Project	IEEE 802.16 Broadband Wireless Access Working Group < http://ieee802.org/16 >	
Title	On the issue of frame alignment and gaps	
Date Submitted	2007-11-5	
Source(s)	Dorin Viorel Fujitsu Microelectronics Canada Inc.	Voice: +1 403 207 6311 dviorel@fmci.fujitsu.com
	Michiharu Nakamura Fujitsu Laboratories Ltd	Voice: +81 468 39 5371 michi@labs.fujitsu.com
	Chenxi Zhu Fujitsu Laboratories of America Inc	Voice: +1 301 486 0671 chenxi.zhu@us.fujitsu.com
Re:	In response to the LB#28 reply comments	
Abstract	This document provides proposed text for IEEE P802.16j on frame structure requirements and the definition of RSTTG and RSRTG	
Purpose	Discussion and adoption in the P802.16j draft	
Notice	<i>This document does not represent the agreed views of the IEEE 802.16 Working Group or any of its subgroups. It represents only the views of the participants listed in the "Source(s)" field above. It is offered as a basis for discussion. It is not binding on the contributor(s), who reserve(s) the right to add, amend or withdraw material contained herein.</i>

On the issue of frame alignment and gaps for multihop relay transmissions

Dorin Viorel, Chenxi Zhu, and Michiharu Nakamura

Figure 1 Frame structure (for informaion)

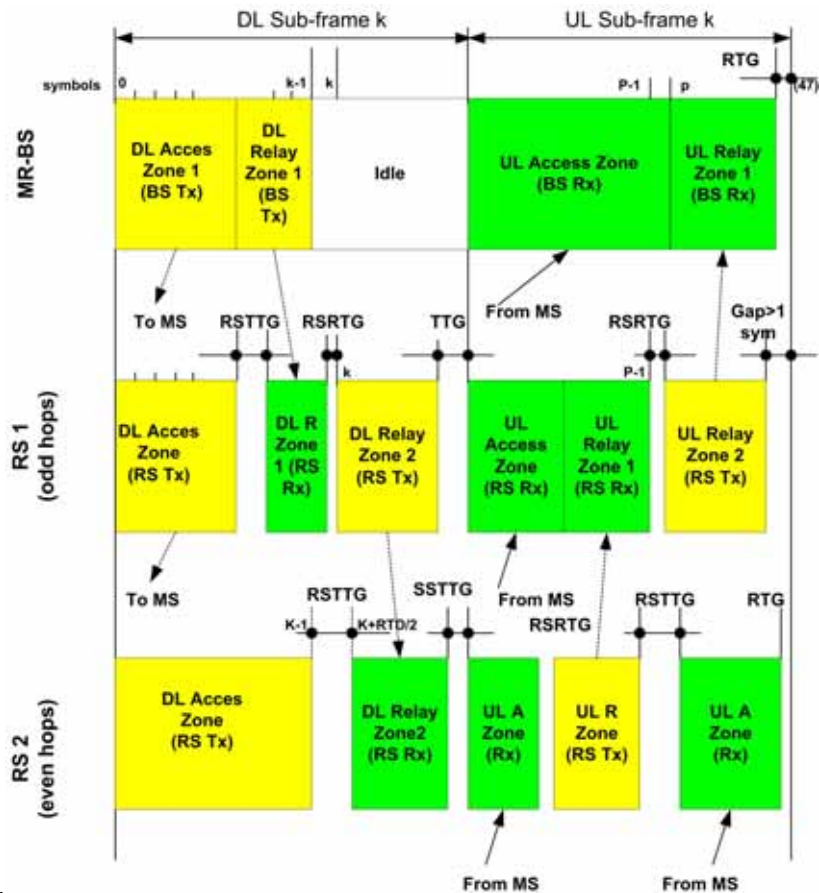
In order to provide support for the one radio RS operation as defined by 802.16j, new gaps (R-TTG and its related RSTTG, R-RTG and its related RSRTG) have been introduced, in order to avoid any data drops due to the Tx/Rx and Rx/Tx switching times.

This contribution provides some information on the specifications of these gaps based on the arrangement of the DL and UL subframe start time arrangement between the MR-BS and RSs.

Figure 1 depicts MR-BS and RS frame structure with highlights of various gaps for information.
